Model	CS130 for Phoenix		Date of Modification	Serial Number
Modified Article	Spring - Exit Sensor			
Reason for Modification	To ensure proper operation of the exit sensor

## MODIFICATION BULLETIN NO. 2

ISSUED ON: May 31, '96

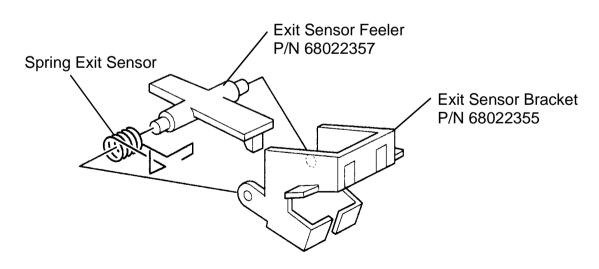
To ensure proper operation of the exit sensor feeler, a spring has been added.

211 241	New P/N	Description	Q'ty Used	Inter- change- ability	Parts Catalog	
Old P/N					Index No.	Page
	A5572143	Spring - Exit Sensor	0 → 1		38	5
